**County of Loudoun**  
**Department of Planning**  
**MEMORANDUM**

**SUBJECT: September 22, 2010 Planning Commission Work Session  
Dulles Town Center  
ZMAP 2007-0001, SPEX 2008-0047 & SPEX 2008-0048**

**SUBJECT:** ZMAP 2007-0001, ZCPA 2007-0001,  
SPEX 2008-0047, SPEX 2008-0048 – Dulles Town Center  
Supplemental Referral – Traffic Study Update

**SUBJECT:** Dulles Town Center – Traffic Impact Study Update  
Loudoun County, Virginia

Figure 3  
Total Future Lane Use and Traffic Control

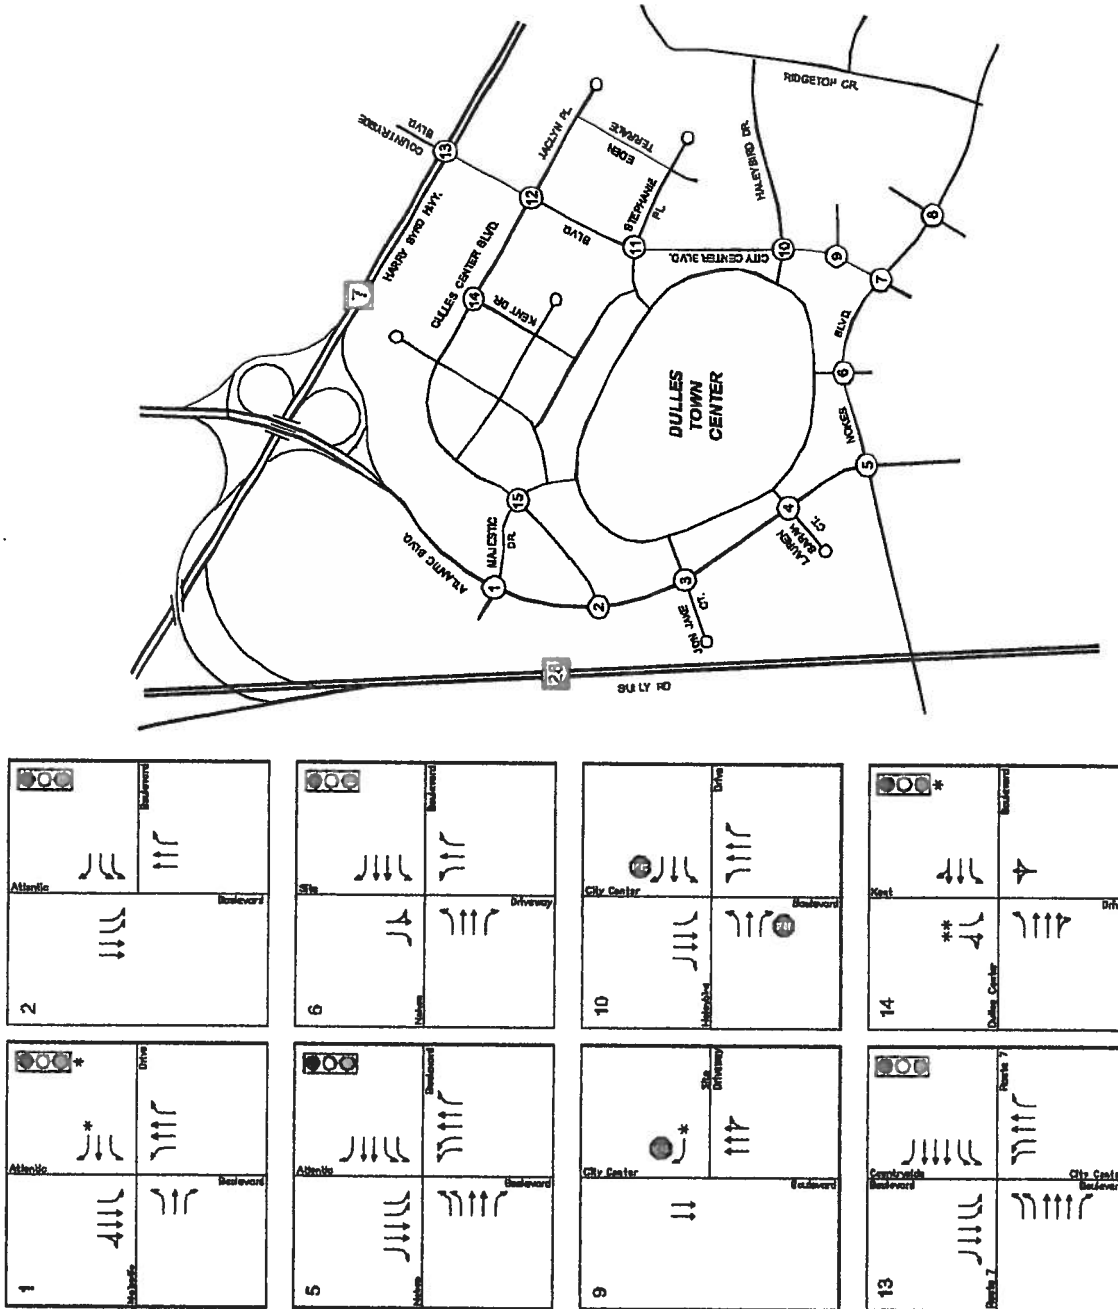
The traffic study update reviewed the impacts of the additional 615,000 sq ft of office development, along with the remainder of the overall proposed development program, on the surrounding road network in 2030. Assuming the “total future” improvements noted in *Attachment 1 (Figure 3)* are in place, the study indicates that the following additional improvements noted in *Attachment 1 (Revised Table 5)*, referred to as the “Condition 4 improvements,” would be required in order to achieve the intersection LOS identified in *Revised Table 5*:

### **Intersection 1 (Atlantic Boulevard/Majestic Drive/Century Boulevard) (with Signalization)**

- Construct/provide second eastbound (Century Boulevard) left-turn lane
- Restripe westbound (Majestic Drive) approach with a shared left-turn/through lane and dual right-turn lanes
- Restripe/reconfigure southbound (Atlantic Boulevard) approach with dual left-turn lanes, one dedicated through lane, and one shared through/right-turn lane
- Optimize signal timings

### **Intersection 4 (Atlantic Boulevard/Lauren Sarah Court) (with Signalization)**

- Construct/provide separate eastbound (Lauren Sarah Court) right-turn lane
- Restripe southbound (Atlantic Boulevard) approach with a dedicated left-turn lane, two dedicated through lanes, and a shared through/right-turn lane
- Optimize signal timings

### **Intersection 5 (Nokes Boulevard/Atlantic Boulevard)**

- Extend southbound (Atlantic Boulevard) right-turn lane back to Lauren Sarah Court
- Optimize signal timings

It is noted that the “total future” improvements identified in *Figure 3* (by asterisks) are the same as those identified in the previous referral and earlier versions of the traffic study.

OTS continues to recommend that the Applicant commit to construction of the “total future” improvements, as well as to the additional “Condition 4 improvements” noted above, at appropriate development thresholds, subject to VDOT approval.
